Clearview Communication Tower - CU

6-6-2013 Submittal

COMMENTS AND PETITIONER REPLY (1st DRC)

Petition Name: Clearview Communication Tower Conditional Use and Variance

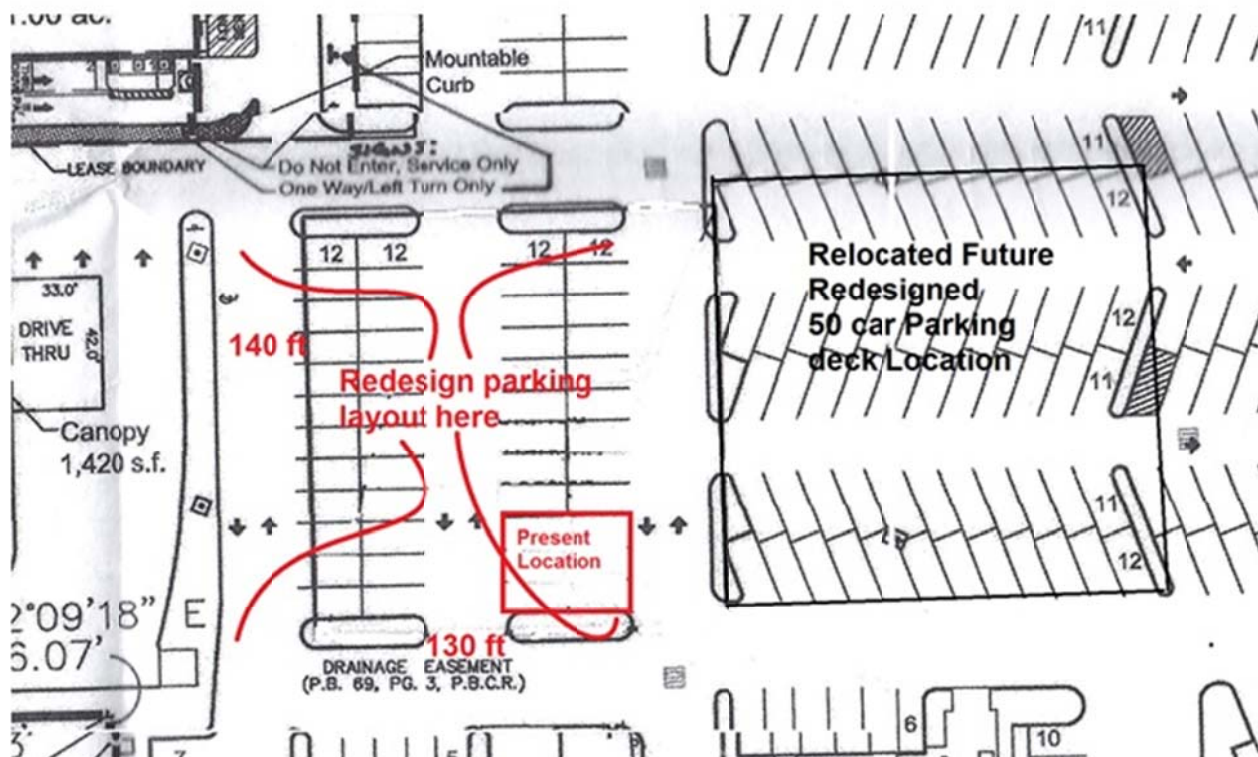
4. Fall zone impacts 3 structures. Certification issue. LDR's basically require applicant to submit any and all engineering data required. Need full set of calculations (assumptions, loads, material data, connection details, calc's, etc.) and construction details to allow verification of structure stability, etc.

We have previously submitted signed and PE sealed Tower plans for the tower and the Fall zone, I am re-attaching them as our reply. Stability is a construction issue not a zoning issue and we will agree to comply at BP process with full soil borings and exact precise calculations.

We have contacted and requested the computer generated calculations for the fall zones from the Tower manufacturer.

Rough Conceptual plans

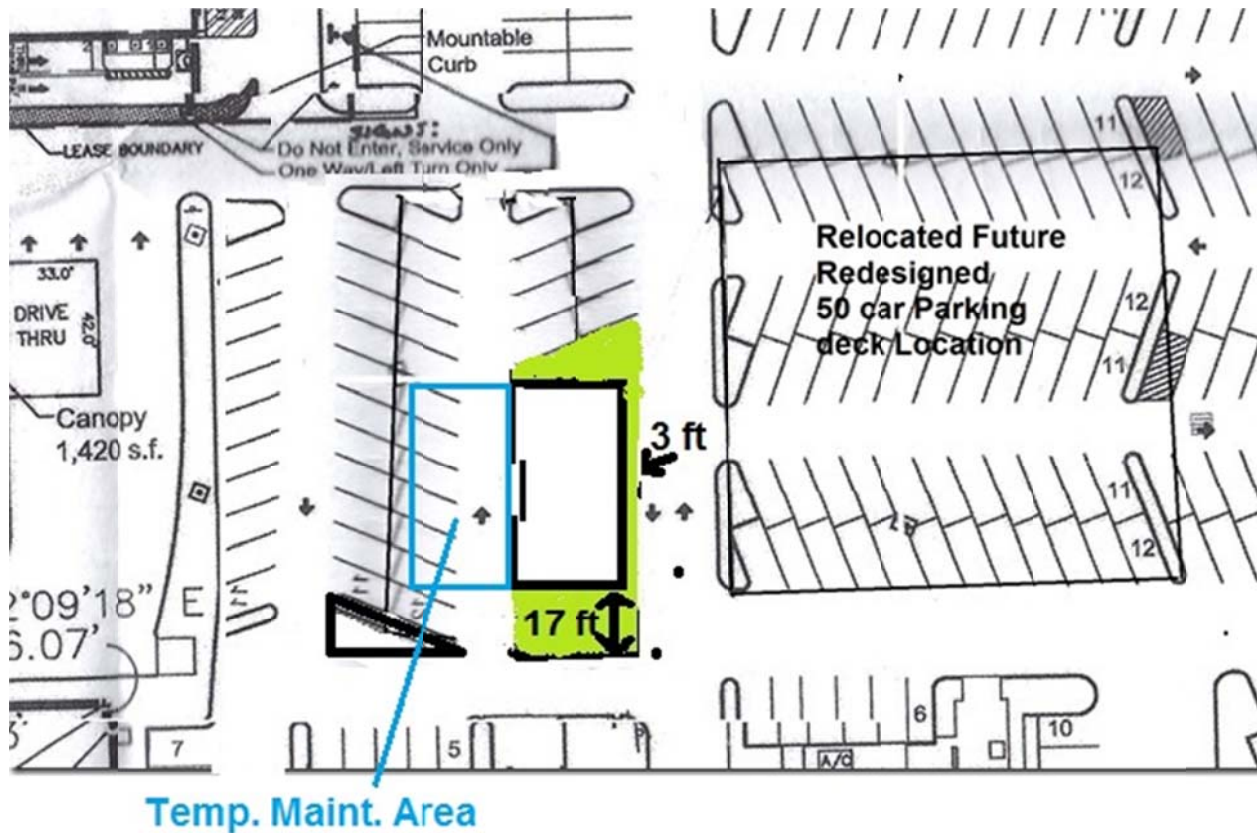
5. Six (6) parking spaces and possibly eight (8) will be eliminated. Need updated parking analysis for entire shopping center. Certification issue. LDR's require adequate facilities (in this case parking) not only for the tower, but also for the shopping center.

Basically moving the deck to the east to this location and redesigning this area, moving the tower compound to the North.

To something like this:

We are increasing the area to the south to 17 ft, with 7 ft over code for landscaping to offset the width of the East side of 3 ft. and net the same required landscaping (per Mr. Flinchum's comments on transferring between sides)

On the north side it will be a variable width but provide the total sq. ft. needed for code. (plus and minus ten ft to average ten feet due to angle.)

On the West side due to shrinking of the width of the compound and the specified work area for Maintenance we propose three pocket sliding gates for access from the newly designed Temp Maintenance area as shown. This side of the fence will be fully gated therefore no landscaping would be required since any landscaping would obstruct us from the designated work area the City Engineer requested.
